DATE: February 17, 2016

AGENDA ITEM # 3

TO: Design Review Commission
FROM: Sean K. Gallegos, Assistant Planner
SUBJECT: 15-SC-43 – 1331 Holly Avenue

Approve design review application 15-SC-43 subject to the findings and conditions

SITE PLAN

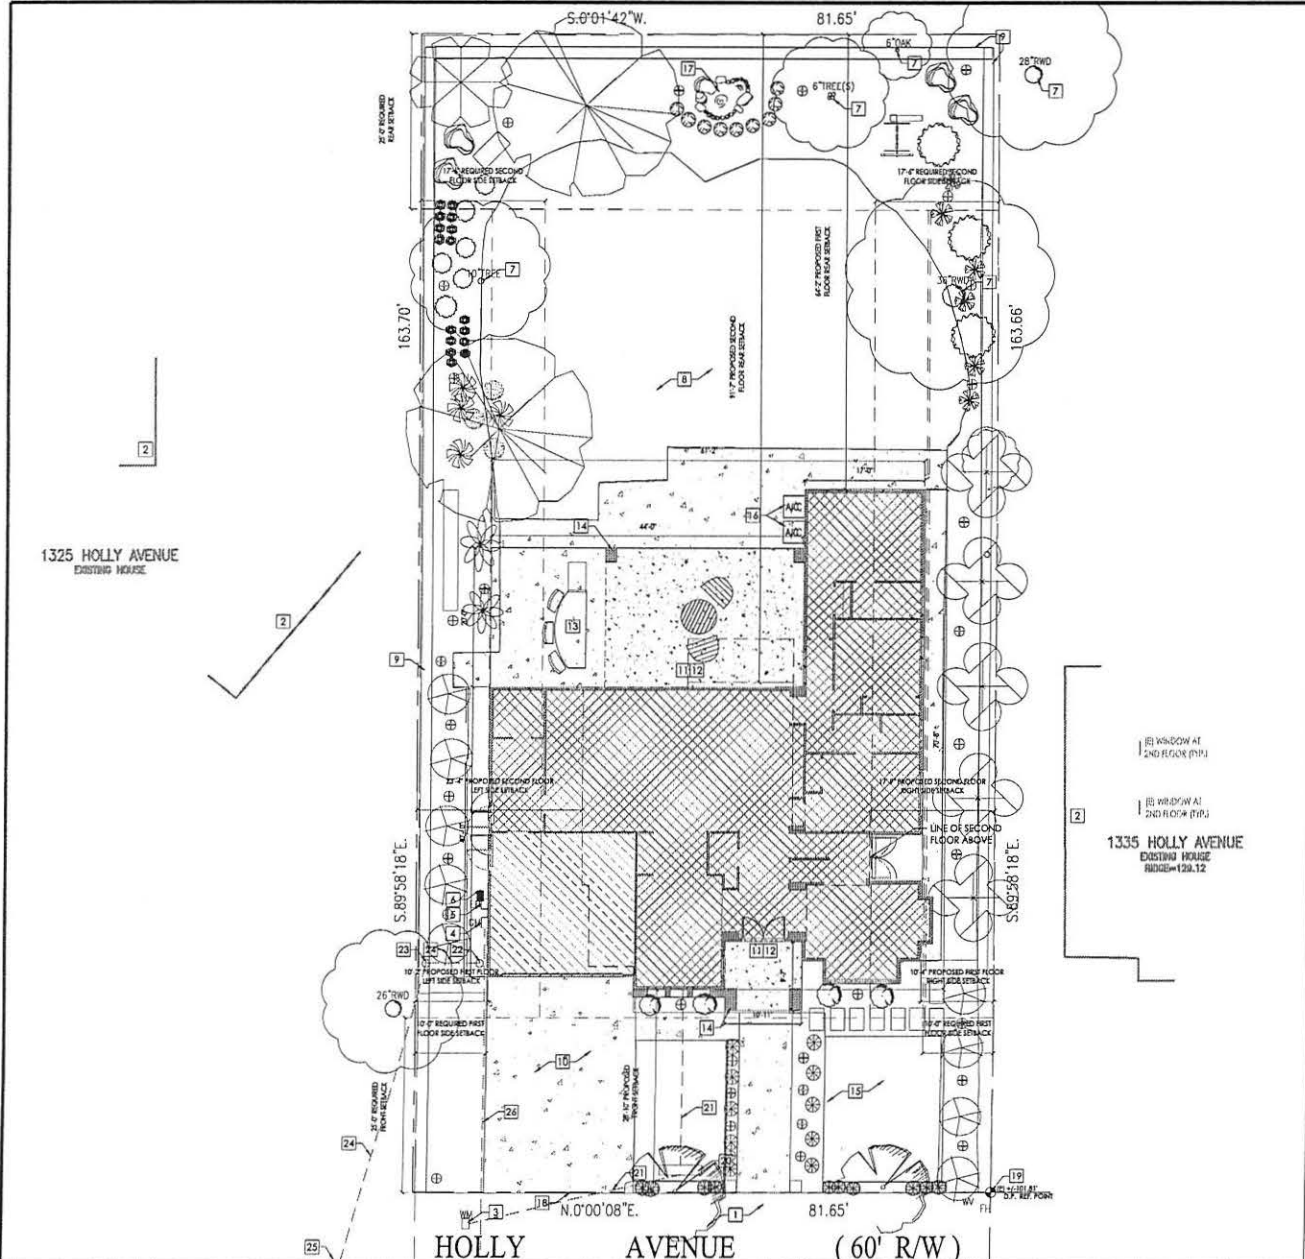
Tree protection fencing shall be installed around the dripline, or as required by the project arborist, of the following trees Nos. 58 and 60-62 as shown on the site plan. Tree protection fencing shall be chain link and a minimum of five feet in height with posts driven into the ground and shall not be removed until all building construction has been completed unless approved by the Planning Division

On the grading plan and/or the site plan, show all tree protection fencing and add the following note: "All tree protection fencing shall be chain link and a minimum of five feet in height with posts driven into the ground."

Show the location of any air conditioning units on the site plan and the manufacturer's specifications showing the sound rating for each unit.
